SUMMARY OF CONCERNS IN RELATION TO THE PROPOSED NORTHCONNEX TUNNEL

This is an objection to many aspects of the proposed NorthConnex tunnel.

SECTION A: THE CONNECTIVITY OF NORTHCONNEX SOUTHERN VENTILATION FACILITY AT THE SOUTHERN INTERCHANGE, THE SOUTHBOUND TUNNEL IN PARTICULAR

Figure 5-18 Northern ventilation facility operational layout

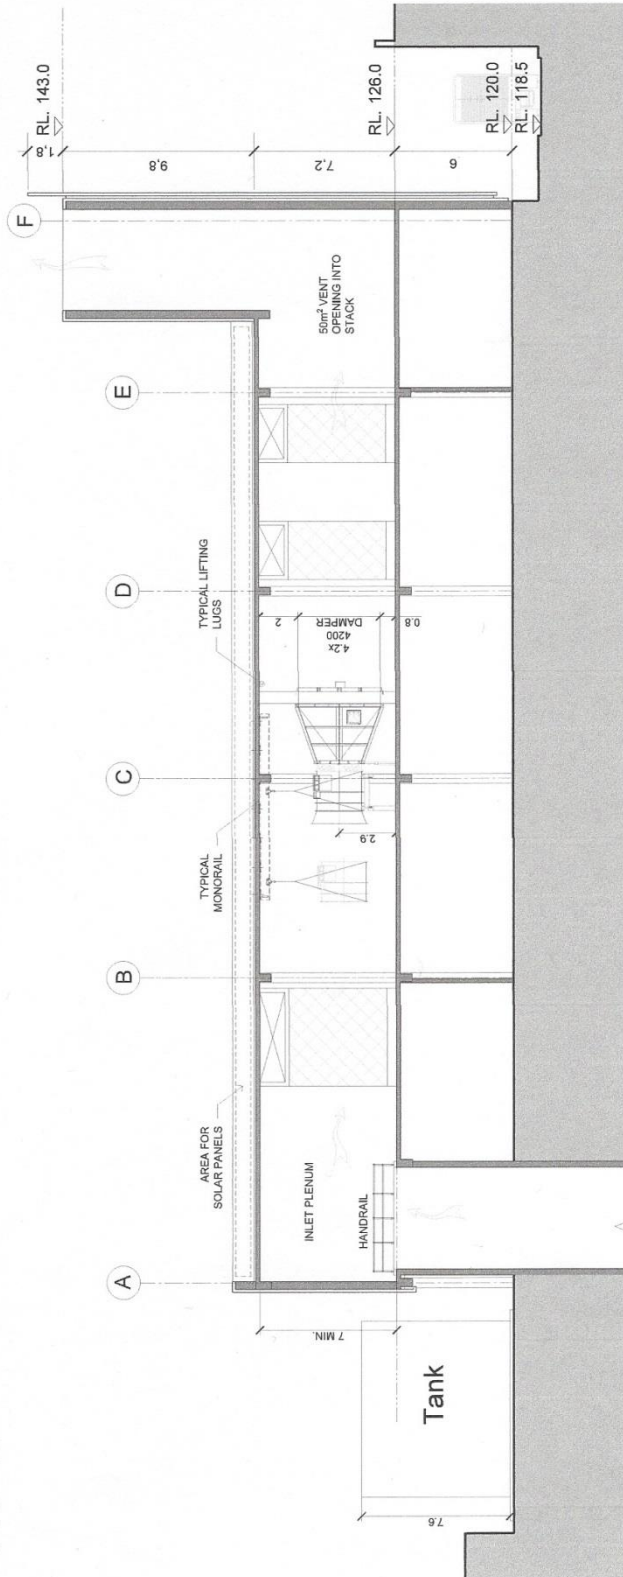
1. EIS Page 103, *Figure 5-14 Indicative tunnel ventilation system northbound tunnel arrangement*

Page 4 below this is a clear diagrammatic depiction of how the Wilson Road, Trelawney Street and Northern Ventilation facilities are connected and how they will work.

There is no such diagram to illustrate how the Southern Ventilation facility is connected and how it will work given that it is across the road and 250 metres (m) from the southbound exit portal onto Pennant Hills Road and approximately 250m from the south-west exit portal onto the M2.

2. EIS Page 105, *Figure 5-15 Indicative Wilson Road tunnel support facility operational layout*

Page 5 below there is clear evidence of connection to the northbound and southbound tunnels.

EIS Page 107, *Figure 5-16 Indicative Trelawney Street tunnel support facility operational layout*

Page 6 below it is obvious in the diagram that the facility is directly over the tunnels.

EIS Page 113, *Figure 5-18 Northern ventilation facility operational layout*

Page 7 below there is a clear connection between the ventilation facility and the tunnel.

EIS Page 111, *Figure 5-17 Motorway operations complex*

Page 8 below there is no indication of how the ventilation facility will be connected to either the northbound or southbound tunnel, nor is there any indication of how the southbound exit portal onto Pennant Hills Road or the south-west exit portal onto the M2 will be connected.

In each of the above figures for Wilson Road, Trelawney Street, and Northern Ventilation facility, the shafts, emergency smoke extraction buildings, and ventilation facility make a substantial footprint in the construction area; however for the Southern Interchange the ventilation facility is an insignificant part of the construction area. How can this be? The difference in scale does not explain the difference.

- Diagrams need to be provided showing the inter-relation between the shaft, the ventilation outlet and the motorway operations centre with a clear description of what is to be constructed and how it will operate.
- The community needs irrefutable evidence that the polluted air from the southbound tunnel exit portals will not be allowed to flow like an invisible sewer through West Pennant Hills, North Rocks, Carlingford and Beecroft.

MOTORWAY OPERATIONS COMPLEX - SOUTHERN VENTILATION FACILITY - SECTIONS
M1-M2-5000-DR-JD-0525

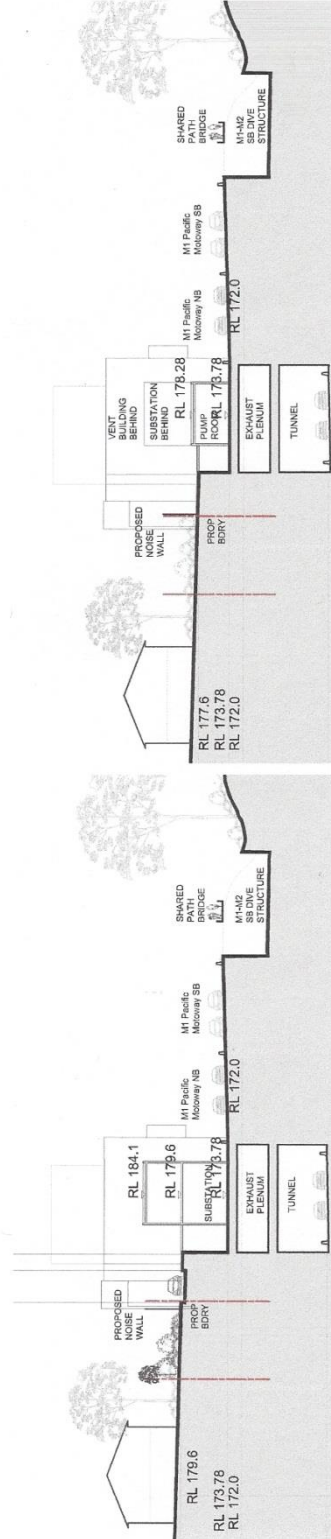
5. *EIS Volume 4, Technical working papers - Urban Design, 6.0 Operational Ancillary Facilities*
EIS Page 99 there is the diagram "Motorway Operations Complex – Southern Ventilation Facility – sections. *Page 10 below* The diagram has the cryptic label "Connection to tunnel TBC". What does TBC stand for? To be considered? Why is tunnel singular? Which tunnel is the diagram referring to northbound or southbound? There is no diagram showing any connection from the Southern Interchange ventilation facility to either the northbound or the southbound tunnel in any way AND YET

Why are there no comparable diagrams for the Southern Interchange and the Southern Ventilation facility?

MOTORWAY OPERATIONS COMPLEX - SOUTHERN VENTILATION FACILITY - SITE SECTION 1-1
M1-M2-5000-DR-UD-0713

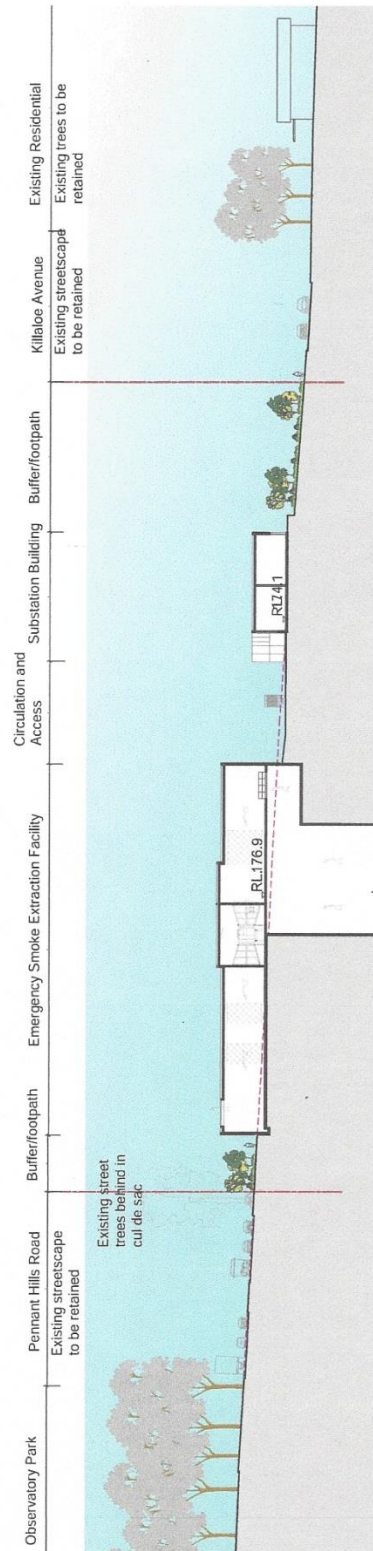
6. *EIS Volume 4, Technical working papers Urban Design, 8.0 Landscape Design*
EIS Page 176 is the diagram "Motorway Operations Complex – Southern Ventilation Facility – Site 1-1". *Page 13 below* The diagram does not show any connection to either the northbound or southbound tunnel. In the same Landscape Design section, EIS Page 182 is the diagram "Wilson Road Tunnel Support Facility –Section" *Page 14 below* which clearly shows the connection to the tunnels. In the same Landscape Design section, EIS Page 189 is the diagram "Northern Ventilation Facility – Landscape Concept Section". *Page 15 below* This also clearly shows the connection to the tunnels.
